NIE Networks Generator Interface Protection Amendment Project

Distribution Code Consultation Document

18th July 2017

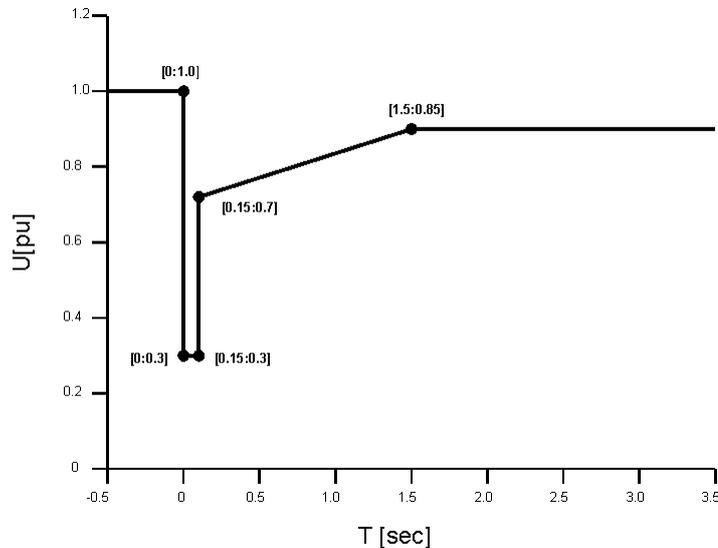
There are different Protection settings dependent upon size of the **Power Station**.

<u>Protection Function</u>	<u>Power Stations \geq 16A/phase and $<$5MW</u>		<u>Power Stations \geq5MW</u>	
	<u>Setting</u>	<u>Time Delay</u>	<u>Setting</u>	<u>Time Delay</u>
<u>U/V stage 1</u>	<u>0.9pu^{\$}</u>	<u>0.5s</u>	<u>0.85pu^{\$}</u>	<u>3.0s</u>
<u>U/V stage 2</u>	<u>N/A</u>	<u>N/A</u>	<u>0.6pu^{\$}</u>	<u>2.0s</u>
<u>O/V</u>	<u>1.1pu^{\$}</u>	<u>0.5s</u>	<u>1.1pu^{\$}</u>	<u>0.5s</u>
<u>U/F</u>	<u>48Hz</u>	<u>0.5s</u>	<u>48Hz</u>	<u>0.5s</u>
<u>O/F</u>	<u>50.5Hz</u>	<u>0.5s</u>	<u>52Hz[#]</u>	<u>1.0s</u>
<u>LoM(RoCoF)[¥]</u>	<u>0.125 – 0.4Hz/s^{\$}</u>	<u>0s</u>	<u>1.5Hz/s</u>	<u>0.3s[∞]</u>

Notes: [∞] The required protection requirement is expressed in Hertz per second (Hz/s). The time delay should begin when the measured rate exceeds the threshold expressed in Hz/s and be reset if it falls below that threshold. The relay must not trip unless the measured rate remains above the threshold expressed in Hz/s continuously for 300ms. Setting the number of cycles on the relay used to calculate the RoCoF is not an acceptable implementation of the time delay since the relay would trip in less than 300ms if the rate was significantly higher than the threshold.

^{\$} 0.125Hz/s is the preferred setting, 0.4Hz/s can be accepted where the **Generator's** studies indicate that nuisance tripping could occur at the lower setting. All **Protection** settings will be agreed between NIE Networks and the **Generator** during the connection process.

- 7.11.2 All **Power Stations** with an output ≥ 16 A/phase and connected to the **System** on or after 1st October 2017 must apply protection settings as per paragraph CC7.11. For the avoidance of doubt, **Power Stations** with an output ≥ 16 Amps/phase and connected on or after 1st October 2017 shall not employ vector shift as a LoM technique.

- 7.11.3 All **Power Stations** ≥ 16 Amps/phase and < 5 MW connected to the **System** prior to 1st October 2017 shall maintain the protection settings as outlined in their **Connection Agreement**.

- 7.11.4 All **Power Stations** ≥ 5 MW connected to the system prior to 1st October 2017 shall ensure that the **Protection** settings as per paragraph CC7.11 are applied by 31st December 2017.

Fault Ride Through Capability for Power Stations \geq 5MW connected to the Distribution System

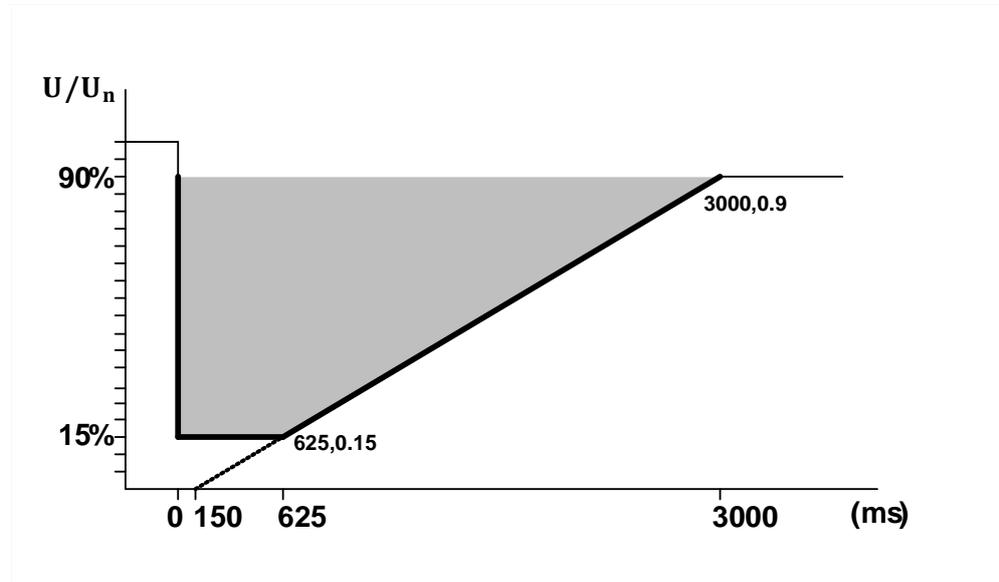
[7.10.2-7.12.2](#) A **Power Station** with a **Registered Capacity >5MW** shall have the technical capability to remain connected to the **Distribution System** for voltage dips on any or all phases, and remain stable, where the **Distribution System** phase to phase voltage measured at the **Connection Point** remains above the heavy black line in the diagram below titled “Fault Ride-Through Capability for Generation units ≥ 5MW connected to the Distribution System”.
